Clinton Power Station

Clinton Power Station, Unit 1
Facility Operating License No. NPF-62
NRC Docket No. 50-461

Subject: Request for Amendment to Technical Specifications to Permit Inclined Fuel Transfer System Blind Flange Removal During Power Operations

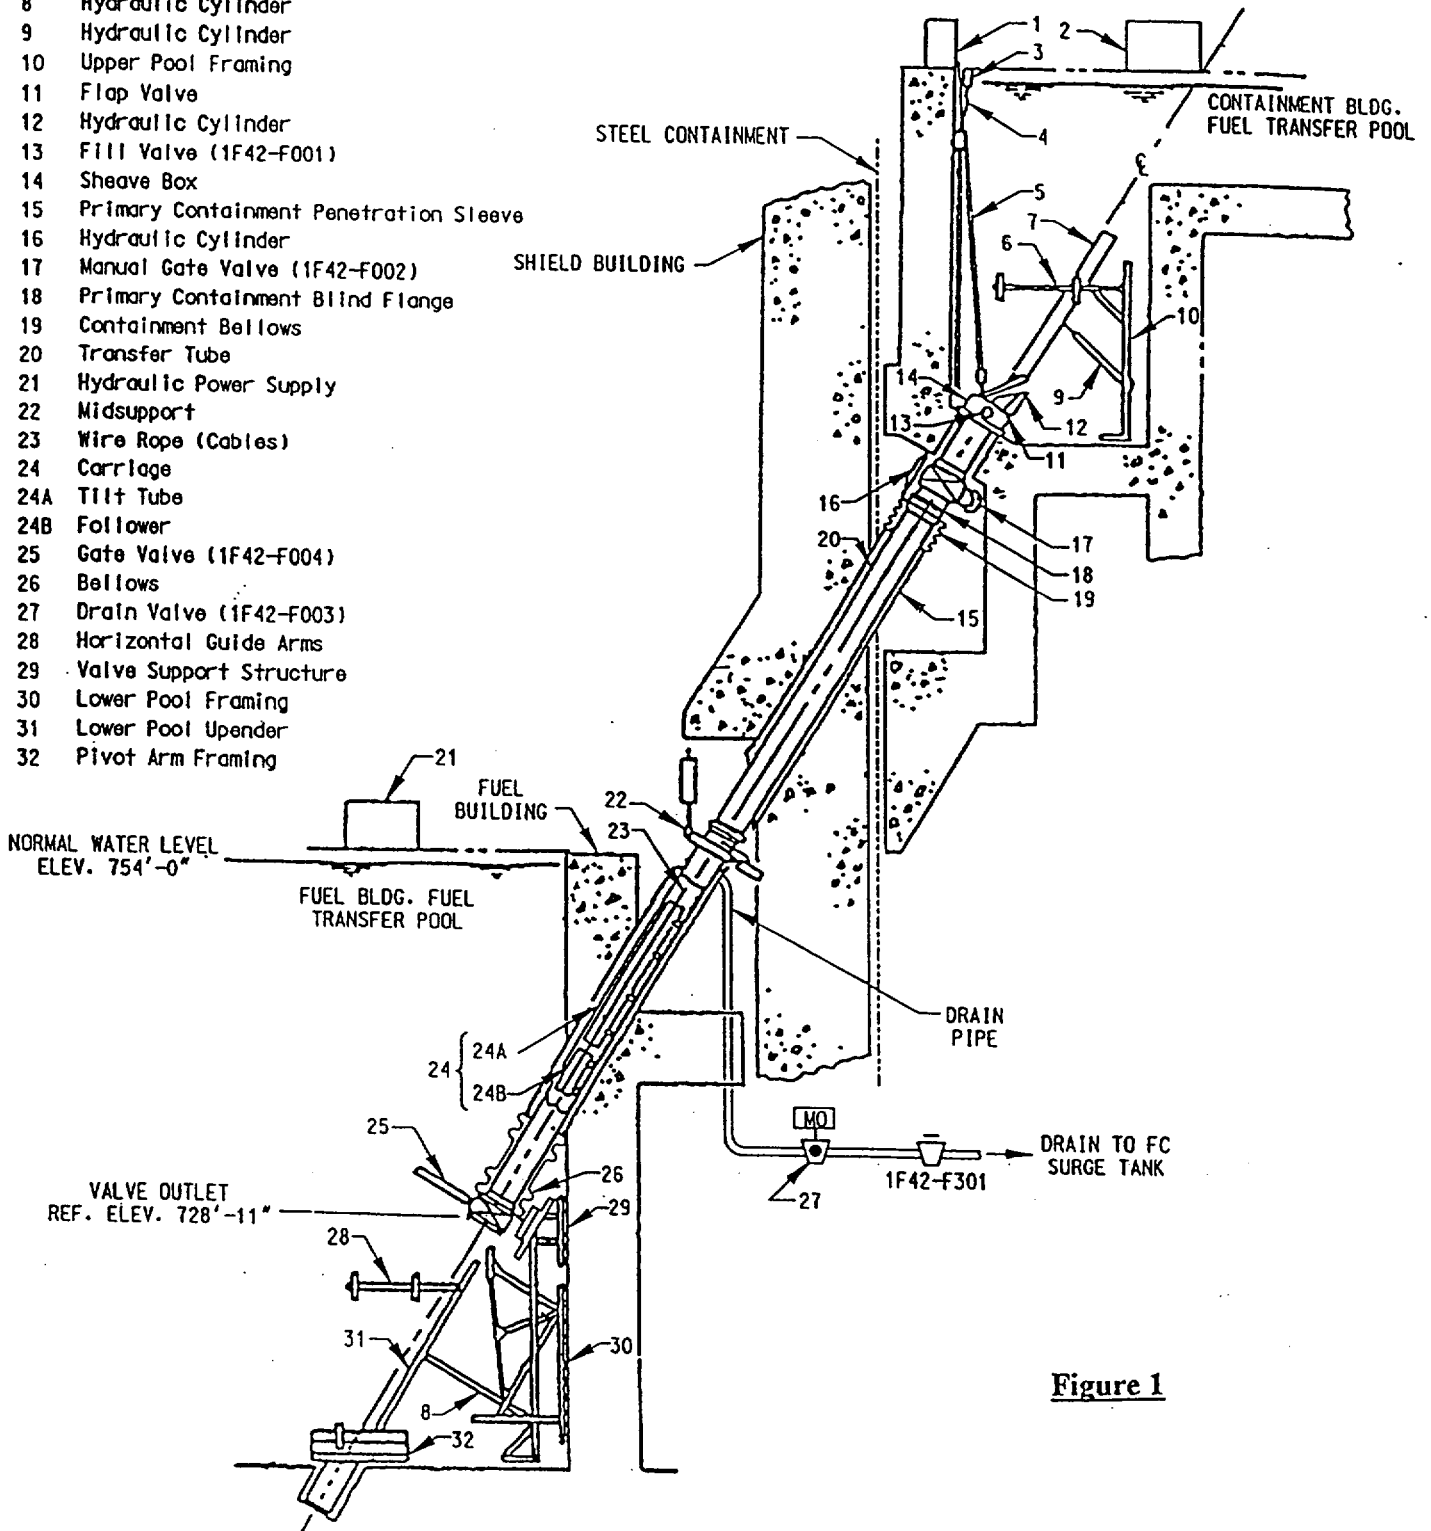
The IFTS at CPS (Figure 1) is used to transfer fuel assemblies, control rods, defective fuel storage containers, and other small items between the pool in upper primary containment and the lower-elevation pool in the adjacent fuel building (i.e., secondary containment) by means of a carriage traveling in an inclined transfer tube. The IFTS is a fixed installation, consisting of the inclined fuel transfer tube, upper and lower upenders, hydraulic power units, an electrically powered winch, carriage, and instrumentation required for the control system that includes redundant inputs for status indicators, and both a manual and semi-automatic programmable computer control facility.

The transfer tube (Figure 1, Item 20) is a 23-inch internal diameter stainless steel pipe, and provides a sealable, enclosed path for the carriage which is lowered and raised by means of a winch assembly. In the primary containment pool (i.e., upper pool), the transfer tube connects to the pool penetration and to a sheave box. The position of the carriage in the tube is tracked by a calibrated position system. The transfer tube is suspended between two flexible seals, or bellows. The transfer tube includes a valve at both ends, and is provided with a primary containment isolation assembly. The valve at the upper end, known as the flap valve (Figure 1, item 11), consists of a 24-inch disc with an actuating cylinder (Figure 1, item 12) and is mounted on the sheave box (Figure

The primary containment isolation assembly consists of two pipe spools separated by a removable blind flange (Figure 1, item 18) that is connected to the primary containment penetration via a flexible metal bellows (Figure 1, item 19). The blind flange normally forms a part of the primary containment boundary. Before the IFTS can be placed in operation, the containment isolation assembly must be disassembled and the flange replaced with a gasketed ring, and reassembled. The spring hanger and snubbers (Figure 1, item 22) at the mid-section of the transfer tube provide support and seismic restraint for the system. At the connection of the two transfer tube sections, the 4-inch drain line and the "tube-drained" liquid level sensors are installed.

1. The manual gate valve (Figure 1, item 17) is closed.
2. Bolts are removed from the containment isolation assembly as required to allow insertion of the blind flange (Figure 1, item 18).
3. The transfer tube (Figure 1, item 20) is lowered with the hydraulic cylinders (Figure 1, item 16).
4. The blind flange is inserted and bolts are installed.
5. The transfer tube is pulled up with the cylinders (Figure 1, item 16).
6. The bolts are tightened and the pressure on the cylinders (Figure 1, item 16) is relieved.

With respect to the IFTS and its associated containment penetration, containment operability is made by the blind flange (Figure 1, item 18), containment bellows (Figure 1, item 19), and the steel containment penetration. Special gaskets are provided for leak checking to assure containment isolation. Installation of the blind flange is the normal
